**ARCHITECTURAL REVIEW COMMITTEE
 STAFF REPORT
 AGENDA ITEM NO. 1.D.
 August 11, 2016**

Project Address: 345 El Camino Real
Assessor's Parcel No: 020-276-290, 020-293-040
Application No.: PRE-16-002
Zoning District: C (General Commercial)
General Plan Classification: Transit Oriented Development
Transit Corridors Plan: El Camino Real Character Area
Prepared by: Matt Neuebaumer, 650-616-7042

Request for an Architectural Review Permit to allow the construction of a five-story car dealership per Chapter 12.108 of the San Bruno Municipal Code. YSM Design (Applicant), Cappo Properties, LLC (Owner).

RE: 345 El Camino Real | HONDA

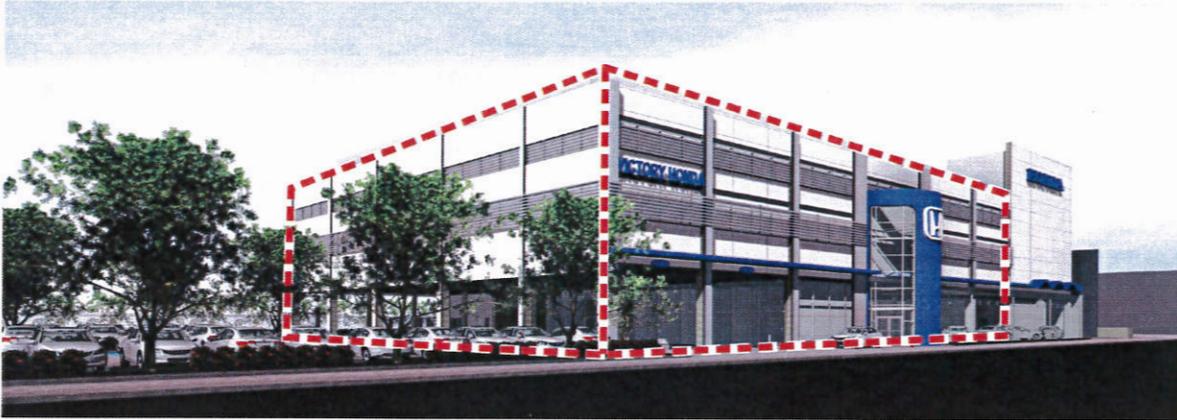
1. Access to the facility appears to be available only via southbound traffic on El Camino Real. A traffic analysis will be required to further analyze ingress/egress.

2. Access to the customer parking lot would be very limited at any time that the auto drop off area was fully occupied.
3. Pedestrian links between customer parking and the Showroom and Parts Department are weak.

4. Street trees are missing which would be in conflict with the following TCP guideline.
3-2 Locate street trees and planter strips between sidewalks and roadway to provide a safety buffer for pedestrians from traffic. Allow tree wells and planters to be used instead of planter strips in cases where parking or bicycle lanes are located next to sidewalks.

5. The large amount of exterior concrete paving on the site would not be consistent with the following TCP guideline.
A13-3 Minimize impervious surfaces such as concrete, asphalt and hardscaping, especially for surface parking lots. Utilize permeable joint pavers, porous concrete and asphalt, reinforced grass pavement (turfcrete), cobblestone block pavement, and other similar materials that allow water to infiltrate.

6. The existing trees along Linden Avenue are too small to effectively buffer views to the large building from the adjacent street and neighborhood.

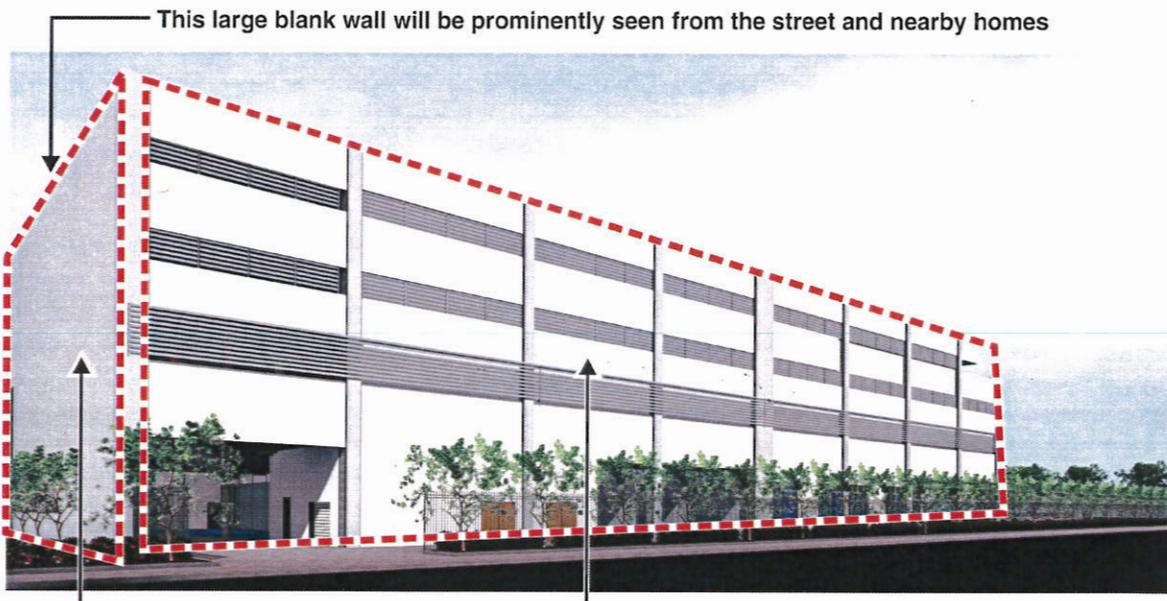
Overall design as a big box with a few embellishments is not consistent with the Transit Corridors Plan Design Guidelines

This large blank wall will be prominently seen from the street and nearby homes

Overall design as a big box is not sensitive to the adjacent residential neighborhood and is not consistent with the Transit Corridors Plan Design Guidelines

1. The overall design as a big box with a few embellishments is not consistent with the following TCP guidelines.

West Elevation Recommendations

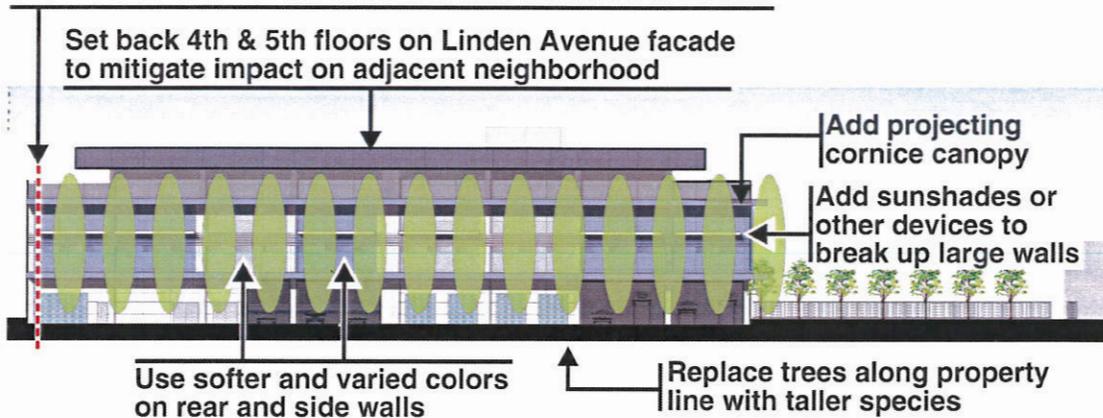
Setting north facade back along adjacent parking lot to allow articulation of the tall blank wall would be desirable

16. Set back the facade above the third floor on the Linden Avenue facade. While this is not mandatory based on the TCP Standards and Guidelines since it is separated from the adjacent residential neighborhood by Linden Avenue, it would be consistent with the spirit of the TCP which encourages larger commercial building to respect the scale of nearby homes.
